ROYAL RANDWICK RACECOURSE SSD-10285 WINX STAND

Response to Submissions

Prepared for
AUSTRALIAN TURF CLUB
9 April 2020

Figure 1 Comparison of the Level 1 design for the original and revised design

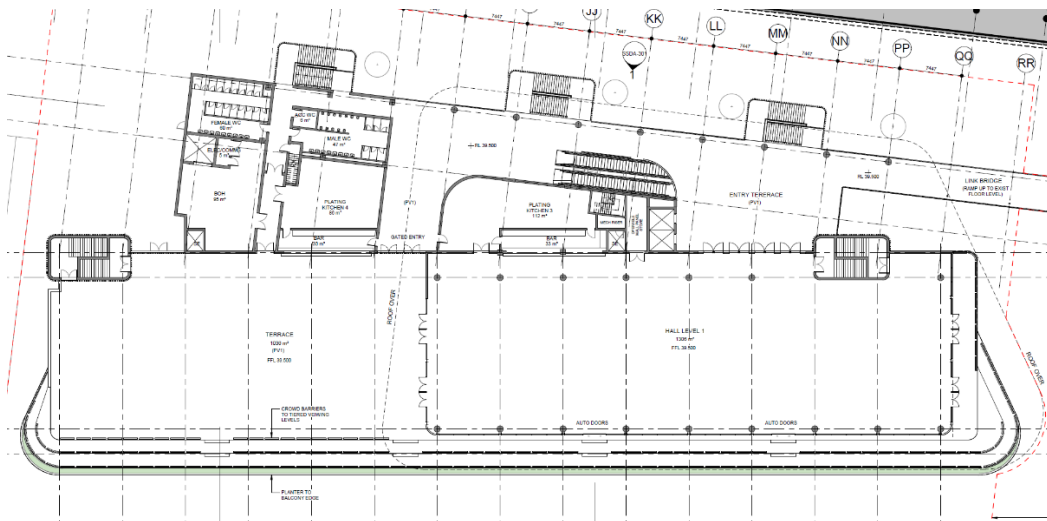
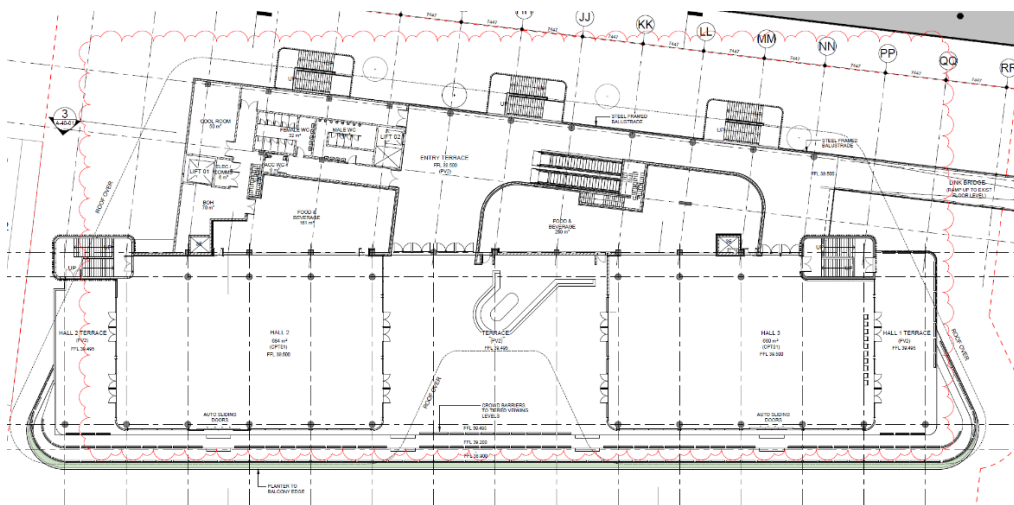
- Revised Level 1 design to spread out the built form massing along the length of the structure to create two separate halls, being Hall 2 – 684sqm and Hall 3 – 660sqm (total of 1,384sqm). This results in a very minor increase of 78sqm to the net total GFA for the hall on Level 1 (original design of the hall on Level 1 was 1,306sqm).
- The previous Level 1 outdoor terrace has been redistributed to a central outdoor terrace between Hall 2 and Hall 3, and two smaller terraces at each end of the structure.
- Revised roof design in response to the revised built form massing.
- Incorporation of solar panels to the roof design to enhance the scheme's environmentally sustainable design and minimise energy consumption.

Figure 3 Amended Landscape Plan with DDA ramp, Ground Floor Masterplan Drawing: DA-1918-02-E

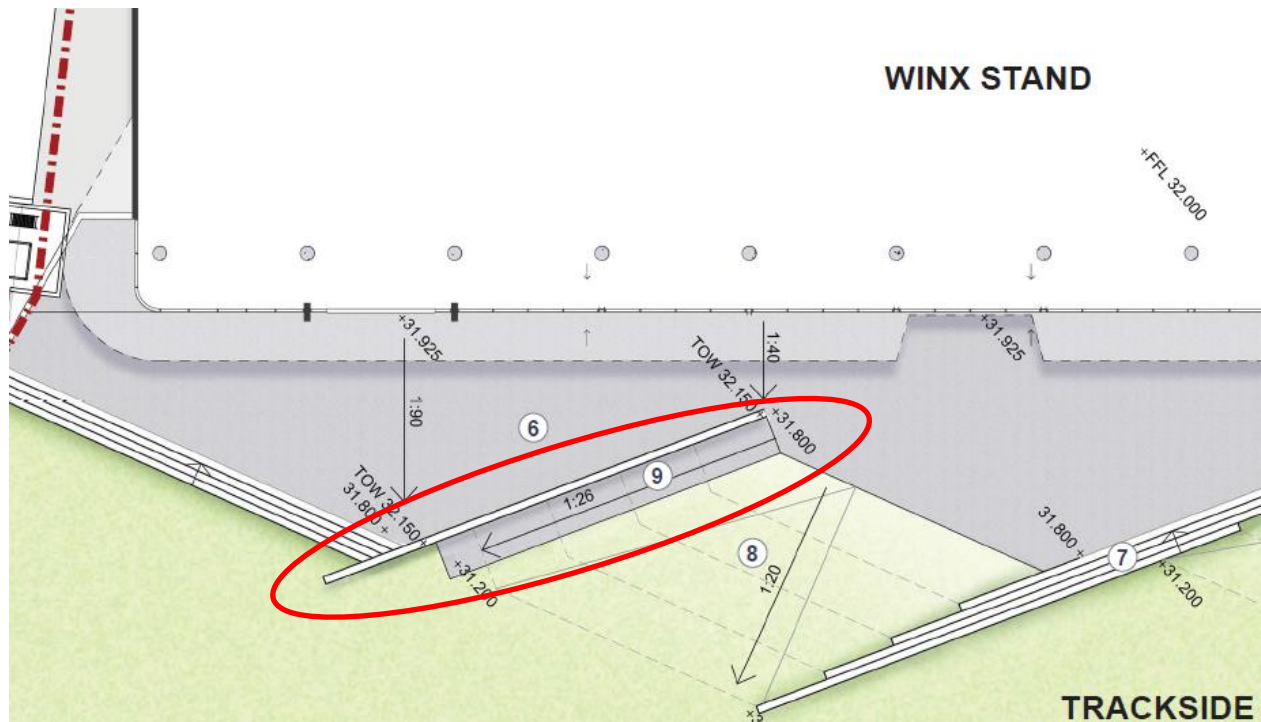
- A new DDA compliant ramp has been added to provide access between the Winx Stand and the trackside lawn area (refer to Figure 3).
- The indicative planting schedule has been amended with alternative vegetation species in response to submissions (refer to Figure 4).

Figure 6 Alternative design review comparing the original design and revised design 1 of 3

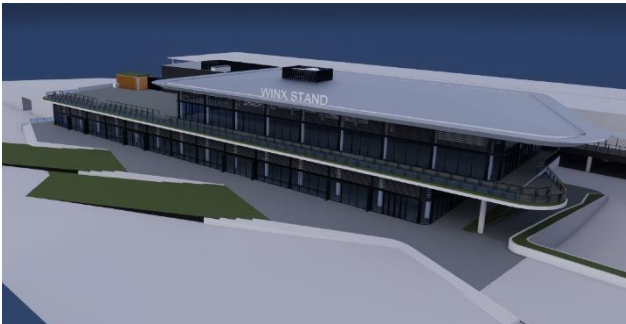
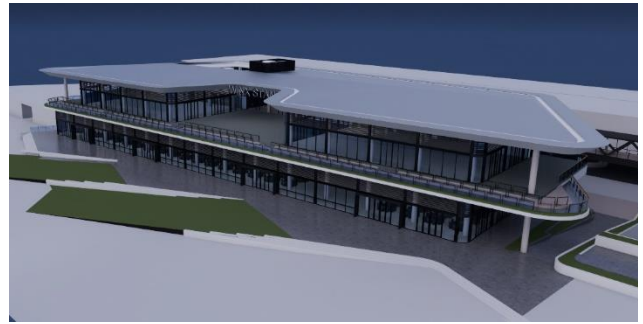
Pictures 9 and 10 illustrate there will be minor design changes visible from the laneway at the rear of the structure. The structure's massing remains consistent with the multi-deck car park.

The revised roof design can be seen in Picture 12 from the laneway looking north. However, it presents a more refined architectural design and will not present any change to visual impact from within the site or from adjoining properties.

Figure 8 Alternative design review comparing the original design and revised design 3 of 3

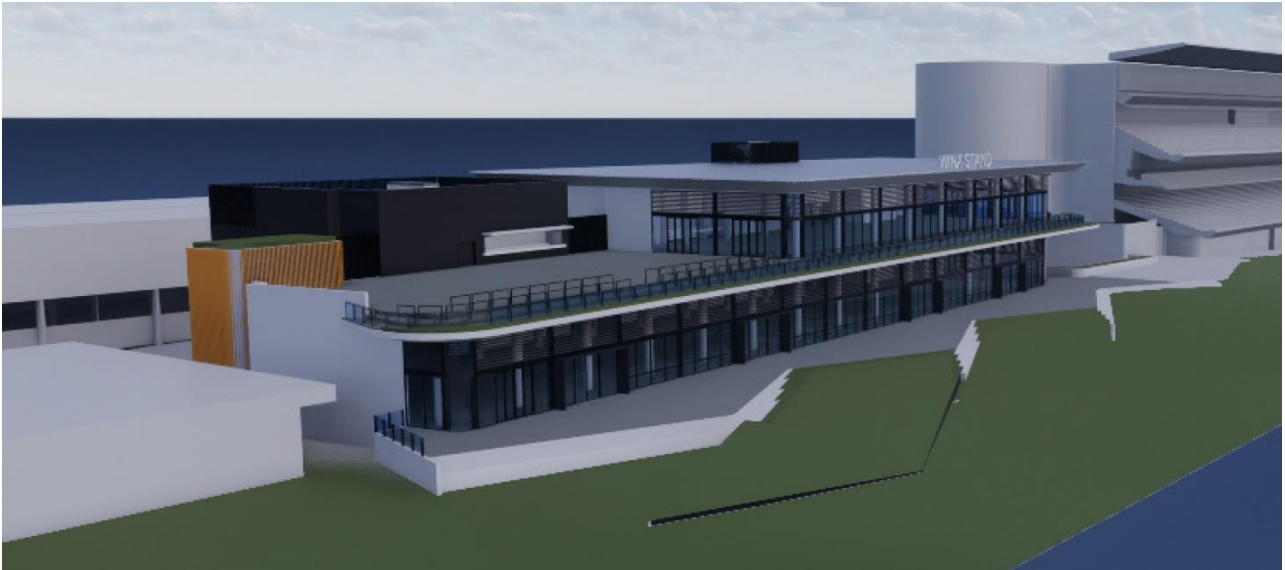
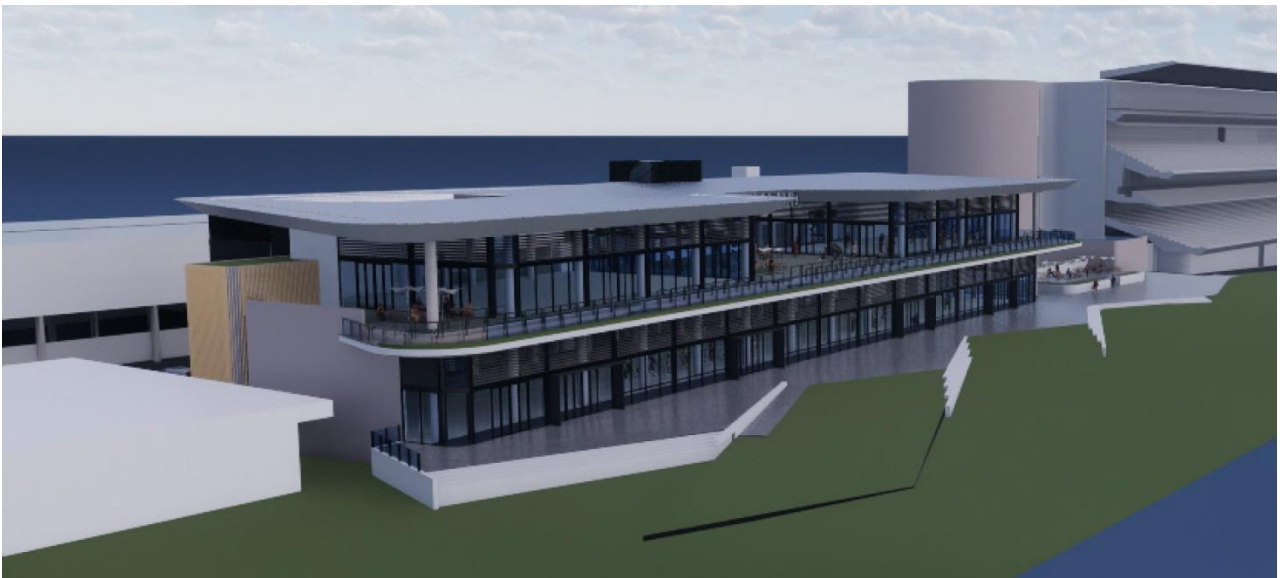
Figure 7 above and Figure 8 on the following page, illustrates that the revised design remains sympathetic to the existing QEII Grandstand to the north. The proposal will maintain the design principle of a stepped transition in height between the QEII Grandstand and the SWAB building to the south. The scale and aesthetics of the revised design for the Winx Stand also remains sympathetic to the broader range of structures on site, including the Multi-deck car park, Theatre of the Horse, and the Members Stand to the far north of the site.

Figure 9 Extract of Scenario 1 from Noise and vibration report

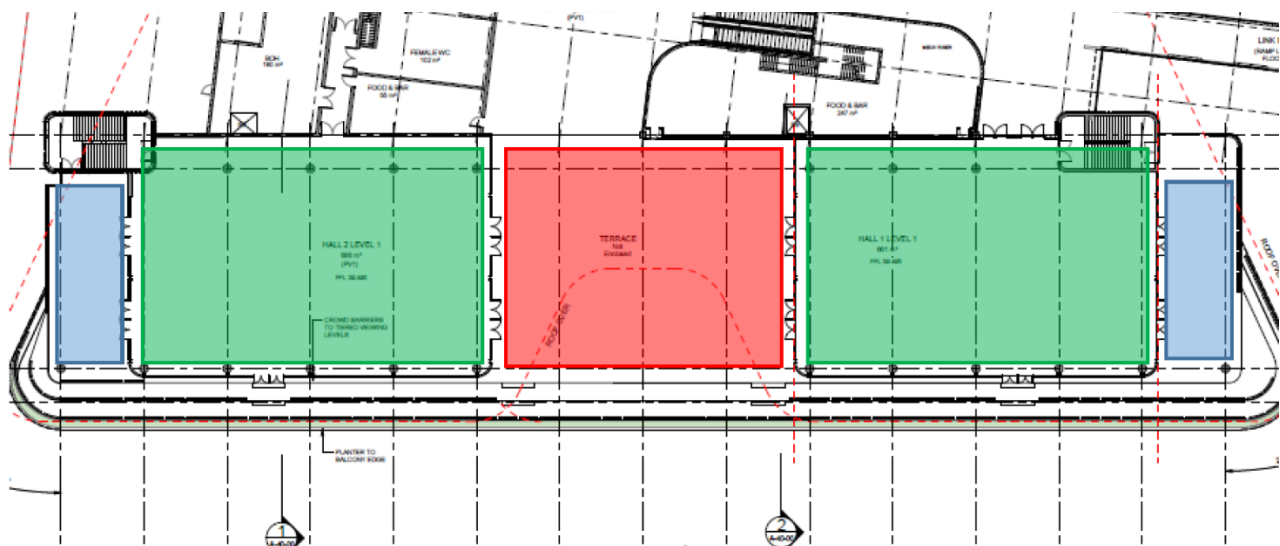
GHD assesses **Scenario 1** as representing maximum capacity from 7:00am to 10:00pm. The facility is at full capacity with live/amplified music played inside the function facility. The assumptions for the scenario are as follows:

- 2870 patrons in total across the facility, including:
 - 1850 patrons within the ground floor internal area
 - 1020 patrons across the first floor area, with the following allocations:
- 30 % of patrons (306) within the south-western indoor function space (shown in green below)
- 30 % of patrons (306) within the north-eastern indoor function space (shown in green below)
- 30 % of patrons (306) on the central terrace between the two indoor function spaces (shown in red below)
- 5 % of (51) patrons on the outdoor area at the south-western end of the building (shown in blue below)
- 5 % of (51) patrons on the outdoor area at the north-eastern end of the building (shown in blue below)
